**EN010122. Comments relating to the Non Material Change application for:
The Oakland's Farm Solar Park Order 2025 (SI 2025/739) & correction 2025 (SI 2025/1070)**

Comments relating to application DMOT/2026/0536

Construction Environment Management Plan (CEMP) for Oakland's Farm Solar Park (EN010122)

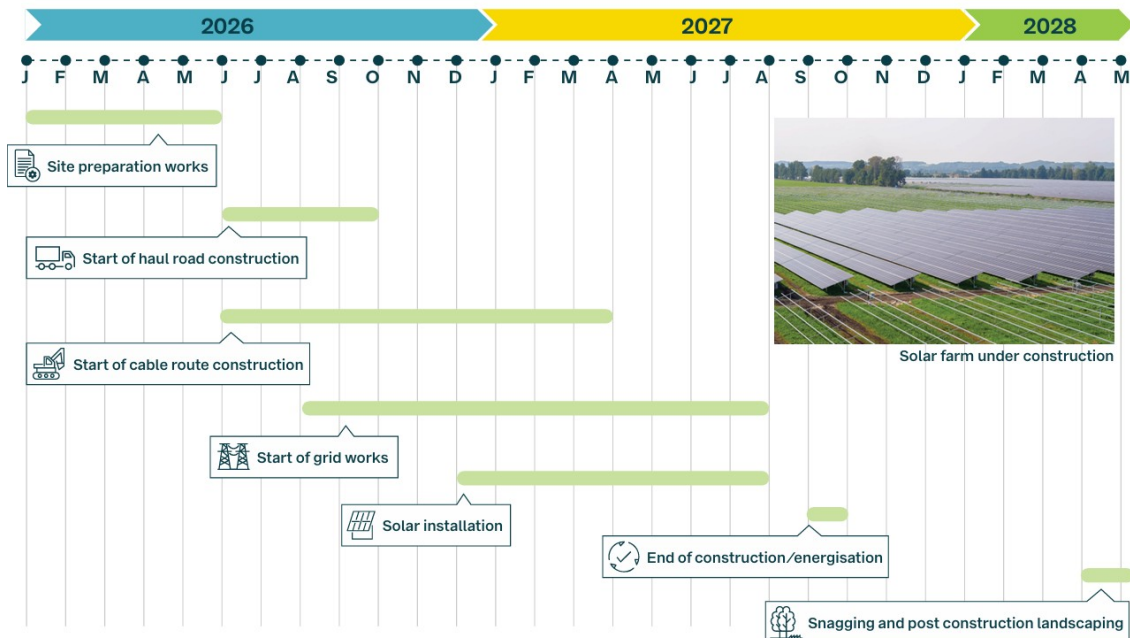
Without the definition of the construction compound locations, fencing and drainage etc (as per 9.3) it is not possible to obtain feedback from the community about these features of the development, and therefore the CEMP cannot be considered to apply to the whole project.
